Palmyra: Proposed Extension and Renovations, New Home Office and Renovations

Response to Conservation Matters raised in Council's Additional Information Request, of 26-Aug-2021

RE : REG REF: SD21B/0372 - Palmyra, Whitechurch Road Additional Information Request

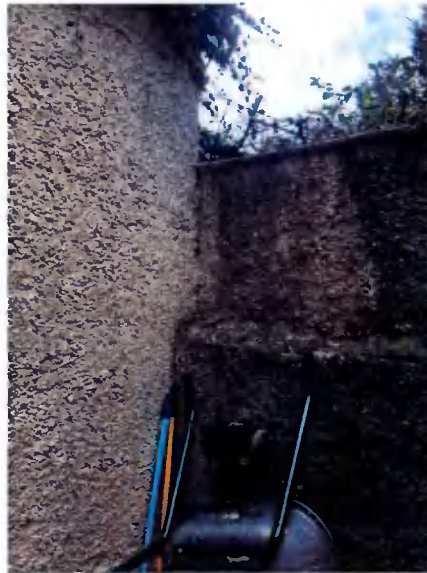
Item 3. Seeks clarification in relation to - Walls of the 19th C. burial site and laneway.

Response: The garden sheds will be demolished, removing roof and concrete block wall facing garden.

2 Interior of sheds showing lane wall at end, Cemetery wall on left and block wall on right. The end and left side walls will be retained, modern block wall on right will be removed. The corrugated roof, which will be removed, slopes right to left from the block wall to rest onto cemetery wall. Roof covering will be removed and disposed of by an Asbestos specialist

- 3 Corrugated cement sheets rest on timber beams, on timber wall-plate atop the cemetery wall. Beams sit on wall-plate, which sits on top of wall so roof structure, wall plate etc., can be removed with no impact upon cemetery wall, as no timbers are built into the structure.

- 7 Roof covering and timbers can be removed without damaging wall.
Ivy and other vegetation will be cleared from the wall
Existing capping will be repaired and any loose stones will be repointed in lime mortar
